## **Appendix 5 – Memo from Abley Transportation Ltd on Transport Matters**

# Proposed Timaru District Plan

## Review of transport submissions

<b>Prepared for</b>	Timaru District Council
<b>Project Number</b>	TDC-J052
<b>Revision</b>	B
<b>Issue Date</b>	04 December 2024
<b>Prepared by</b>	Mat Collins, Associate Transportation Engineer
<b>Reviewed by</b>	Ann-Marie Head, Associate Director - Transportation Engineering

Figure 21.1: PDP Figure 23 - Washdyke Industrial Development Area Plan (showing Road 5)

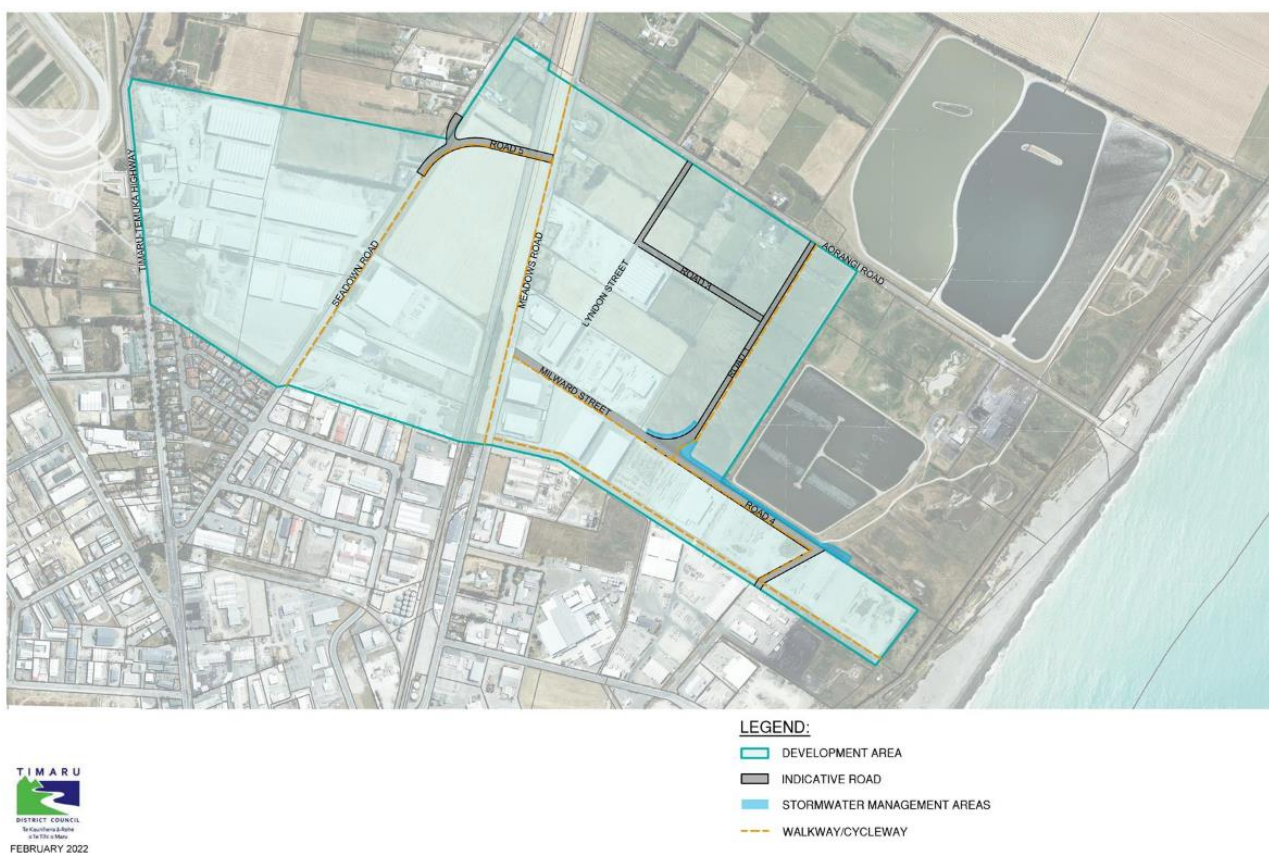
The submitter considers that a new Road (Road 5) to link Seadown Road and Meadows Road, identified in DEV 3 - Washdyke Industrial Development Area Plan (shown in Figure 21.1), should be classed the same as the roads it links.

We understand that the area was rezoned under Plan Change 14. At the time, we understand that both Seadown Road and Meadows Road were classified as Collector Roads, and therefore Road 5 was given the same classification. In the Proposed District Plan, Seadown Road is classified as a Principal Road and Meadows Road is classified as a District Arterial. We therefore support Road 5 being classified as a Principal Road as it will form a natural extension of Seadown Road

Rooney Holdings Limited argues that the proposed new road (Road 5), which will link Seadown Road and Meadows Road as identified in the DEV 3 - Washdyke Industrial Development Area Plan (Figure 21.1), should be classified as a Local Road. The submitter expresses concern that if Road 5 is classified as a higher-order road, the Council should be responsible for its design and construction, and compensation should be provided to the landowner.

The area was rezoned under Plan Change 22, which became operative on July 1, 2021. While the technical assessments for Plan Change 22 were not provided for review, as discussed in Section 21.1 of this technical note, it seems logical to classify Road 5 as a Principal Road since it serves as an extension/realignment of Seadown Road.

**Outcome: We recommend that Road 5 of the DEV 3 - Washdyke Industrial Development Area Plan is identified as a Principal Road. We recommend that road hierarchy change requests for Falvey Road, Levels Plain Road, and Brosnan Road are rejected.**

Figure 21.2: PDP Roding Hierarchy

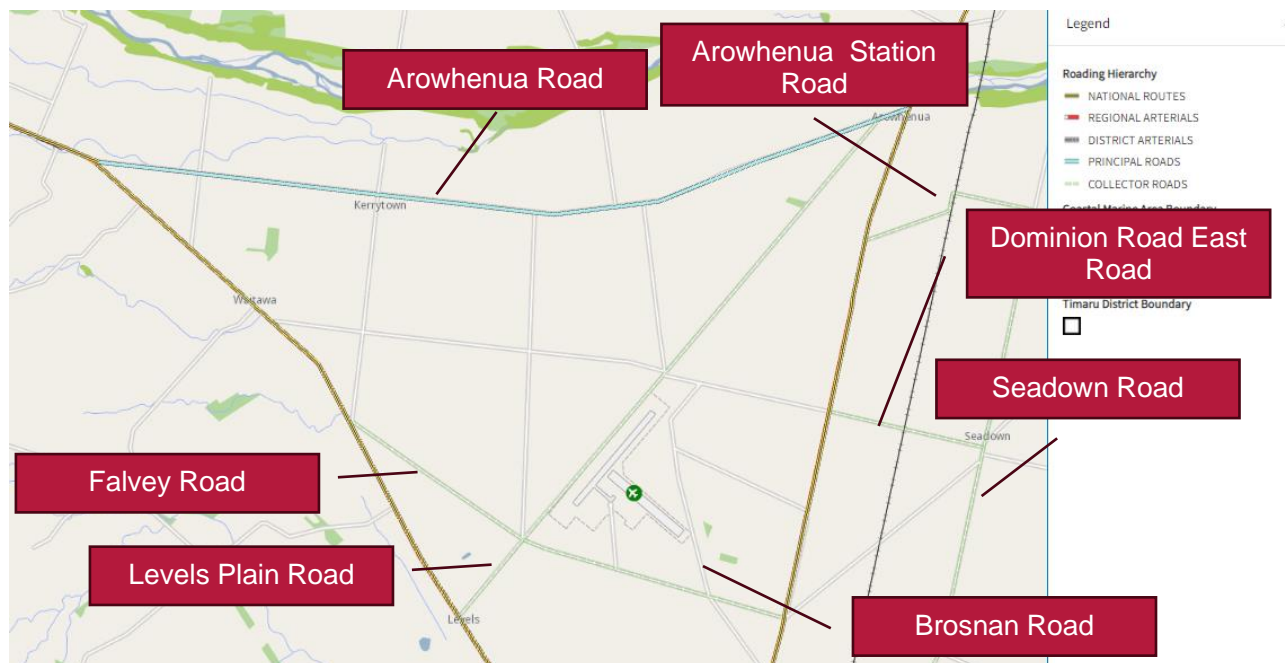
The submitter also requests that Falvey Road, Levels Plain Road, and Brosnan Road be classified as Principal Roads, but no rationale is provided for this request. The PDP Roading Hierarchy near these roads is shown in Figure 21.2:

- Pleasant Point Highway (SH8) and Timaru-Temuka Highway (SH1) are classified as National Routes
- Arowhenua Road is classified as a Principal Road
- Seadown, Dominion Road East, Arowhenua Station Road, Falvey Road and Levels Plain Road are classified as Collector Roads
- All other roads in the area, including Brosnan Road, are unclassified.

We have investigated traffic count data for these roads, however Council does not appear to have this information publicly available. We have therefore referenced MobileRoads for estimates of traffic volumes, which we have reproduced below in Table 21.1. We acknowledge that existing traffic volumes are only one consideration in terms of road classification, however they do give some indication of the current use of the respective roads.

We also reviewed whether Falvey Road, Levels Plain Road, or Brosnan Road were identified in any Transport Strategies as significant. However, we found no references indicating that these roads need to serve a future function beyond their current role, although they all provide access to Timaru Airport.

Figure 21.4 PDP Roading Hierarchy (Kotuku Place)

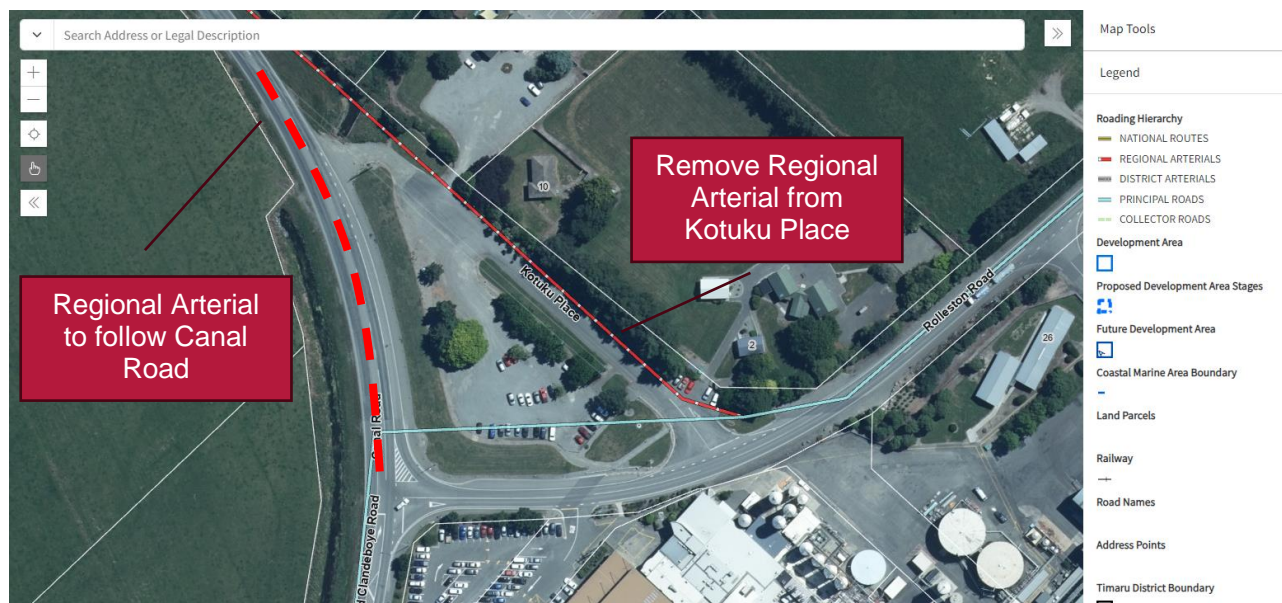
The PDP Roding Hierarchy is shown in Figure 21.3. It appears that the classification of Kotuku Place as a Regional Arterial is a mapping error, and we note that Kotuku Place is not included in SCHED1. We agree with the submitter that Canal Road should be identified as the Regional Arterial and Kotuku Place should have no classification in the Road Hierarchy, we recommend that the GIS layer is updated, refer to our markup in Figure 21.4.

**Outcome: We recommend that submission 165.6 is accepted.**

Figure 21.5 DEV 1 - Broughs Gully Development Area Plan (showing Road 1)

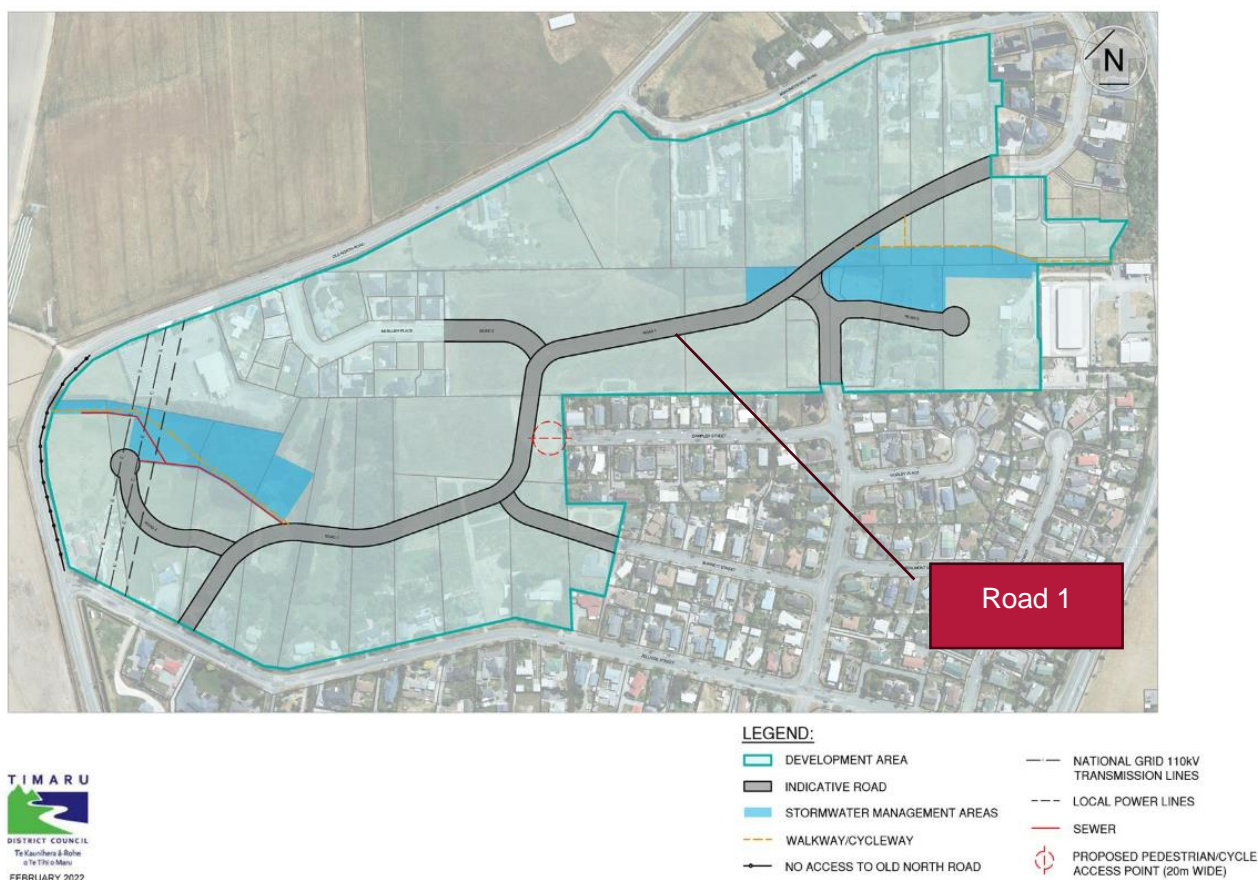
Broughs Gully Development Limited requests clarification whether Road 1 in identified in DEV 1 - Broughs Gully Development Area Plan (shown in Figure 21.1), should be classed the same as the Lancewood Terrace, which Road 1 forms an extension of. Lancewood Terrace is classified as a Collector Road in SCHED1.

DEV 1 - Broughs Gully Development Area Plan does not provide a roading hierarchy for proposed roads, although the Plan Change for the site (PC21) described Road 1 as follows:

This indicates that Road 1 is a higher order road, compared with other roads within the site, and we recommend that Road 1 is classified in SCHED1 as a Collector Road.

**Outcome: We recommend that DEV 1 - Broughs Gully Development Area Plan Road 1 is classified in SCHED1 as a Collector Road**
